ADDENDUM

ADDENDUM #: 03
DATE: February 23, 2026
BID DATE: February 27, 2026, 2:00 PM
SUBMITTED BY: Verde Design Inc.
PROJECT: Lodi High School Athletic Field Improvements
VERDE'S PROJECT NO.: 2502700
FILE NAME AND PATH: Y:\Projects-FO\2025\2502700 - Lodi HS Baseball and Softball Field\Construction Services\Bid Items\20260223_Bid Addendum 03

The changes, clarifications, or modifications to the Lodi High School Athletic Field Improvements Construction Drawings are as follows:

DRAWN BY		CHECKED BY
AL		CS/MB
DATE ISSUED		SCALE
02/23/2026		1"=20'-0"
PROJ. NO.		
2502700		
SHEET NO.		
L9.2

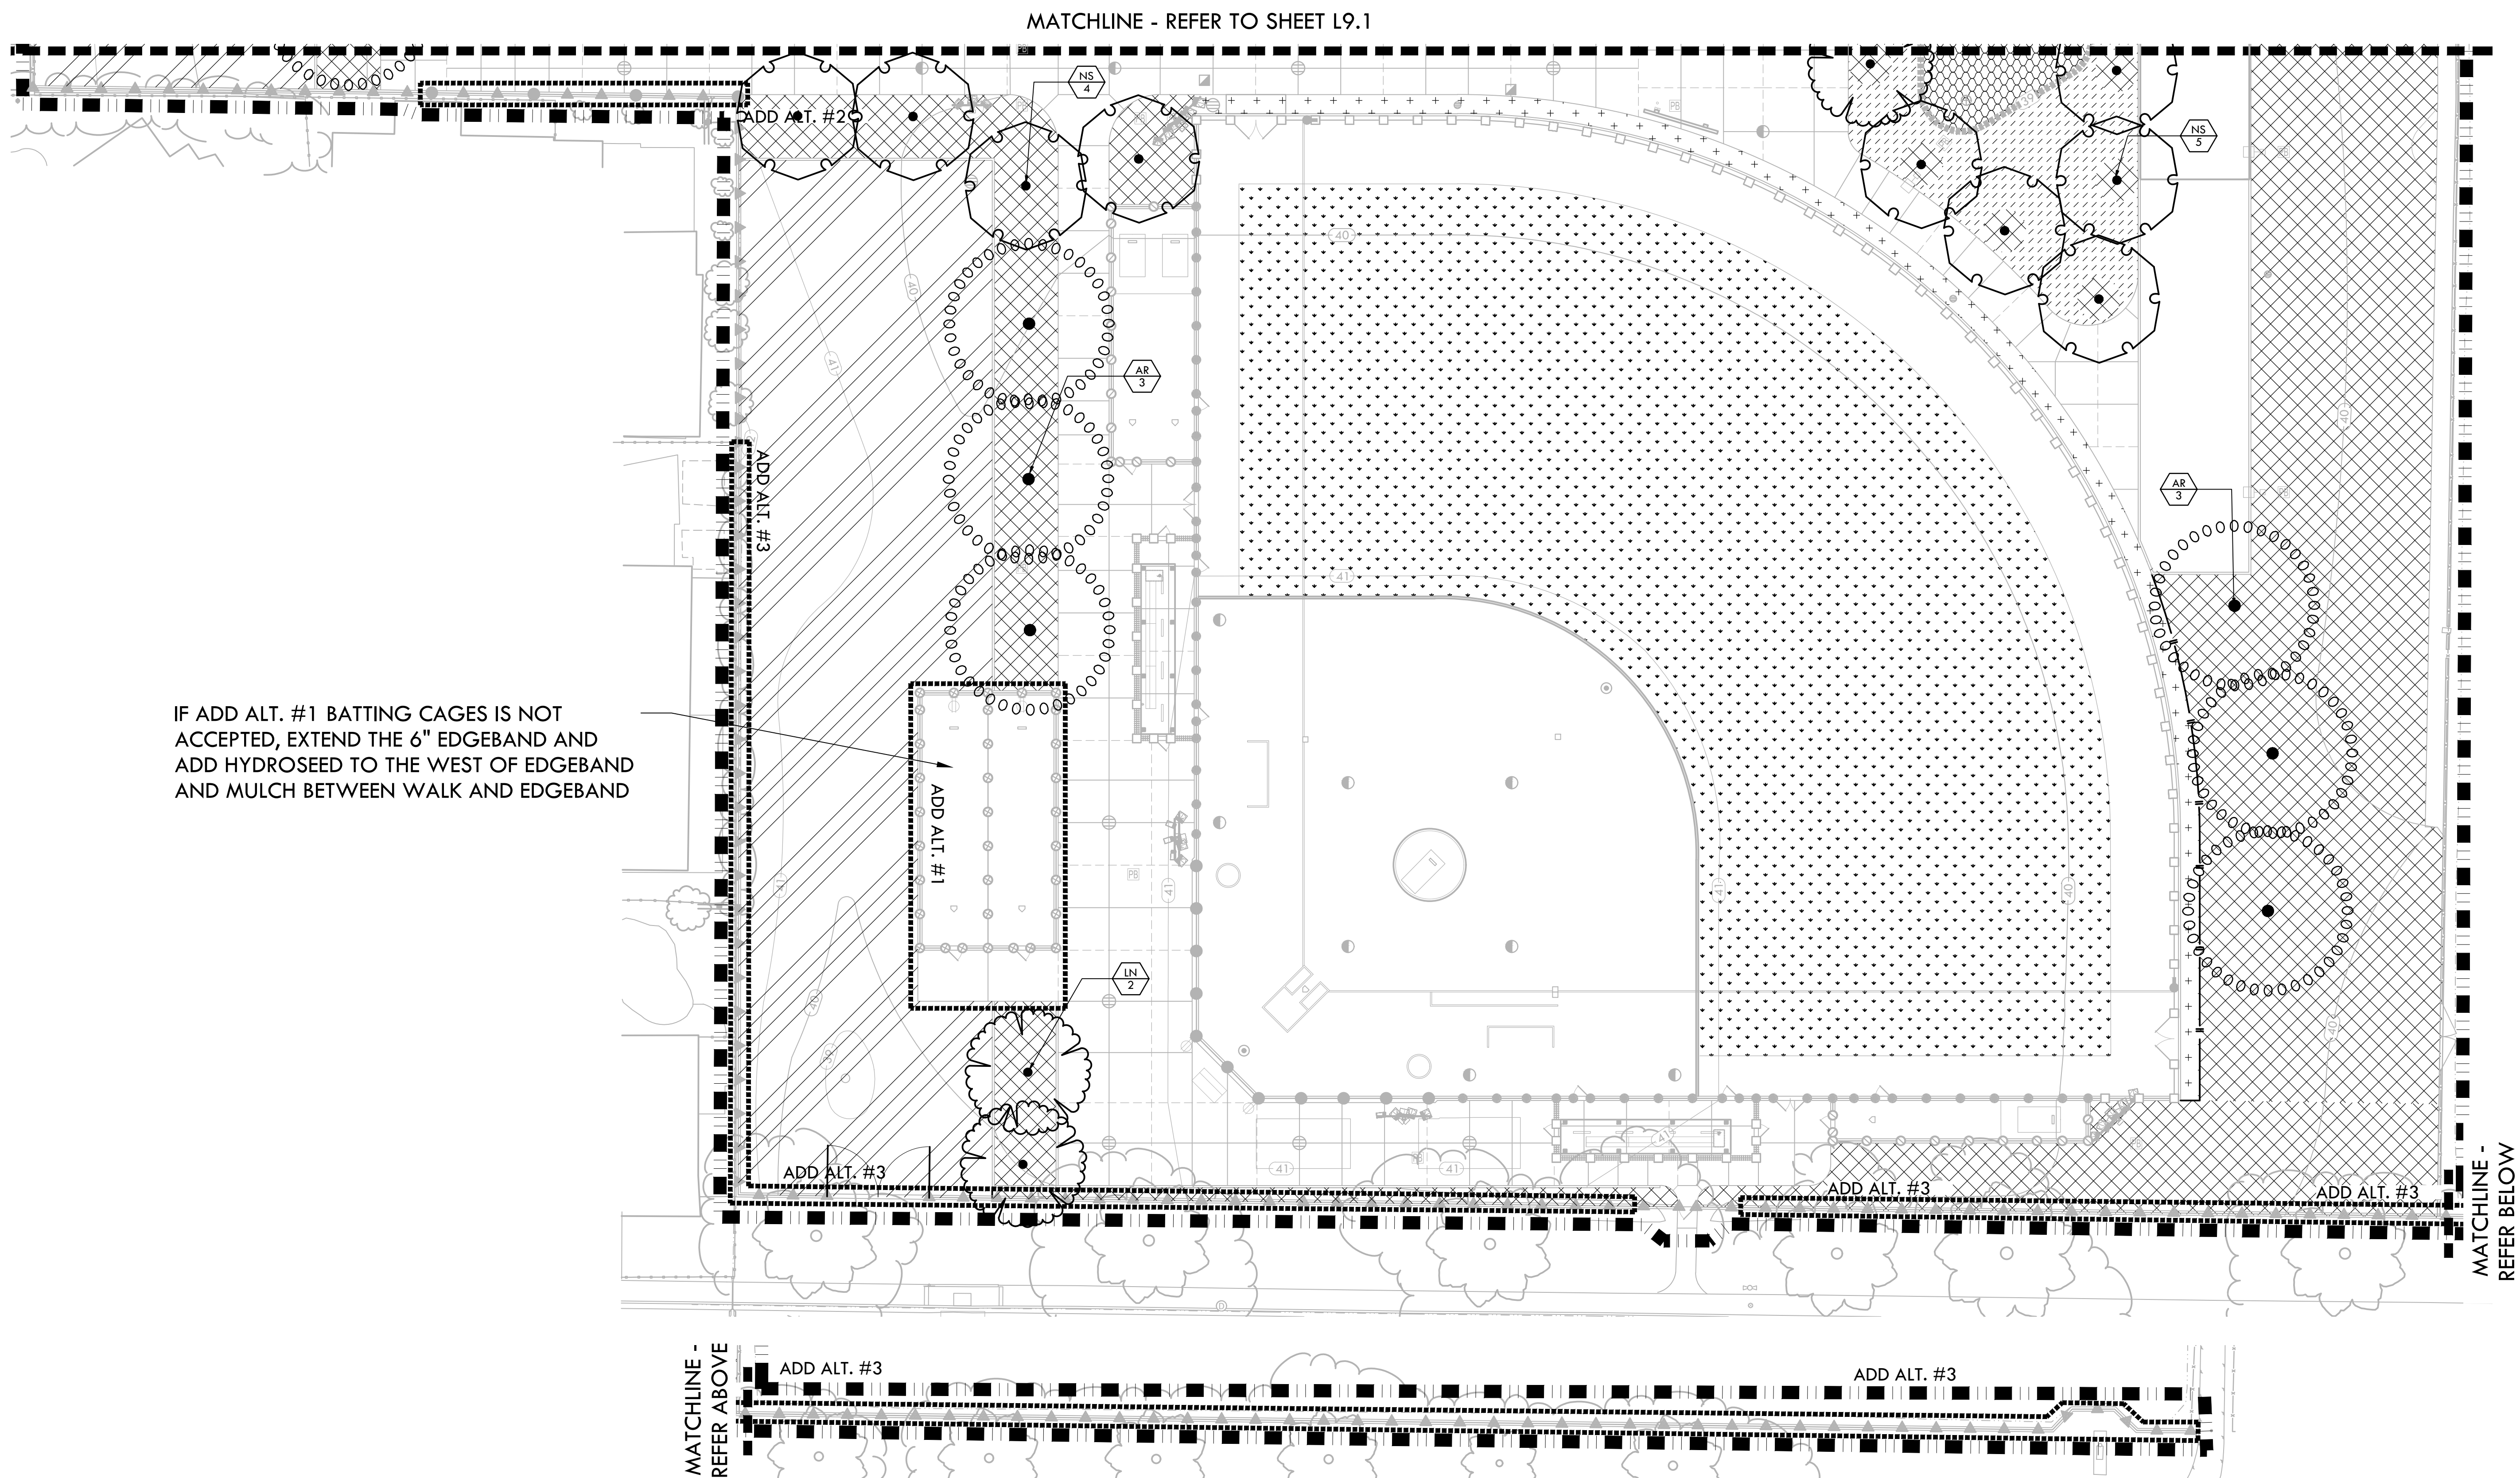
L9.2 – Planting Plan

1. 7' tall x 24' wide double swing gate has been added to the plan set.
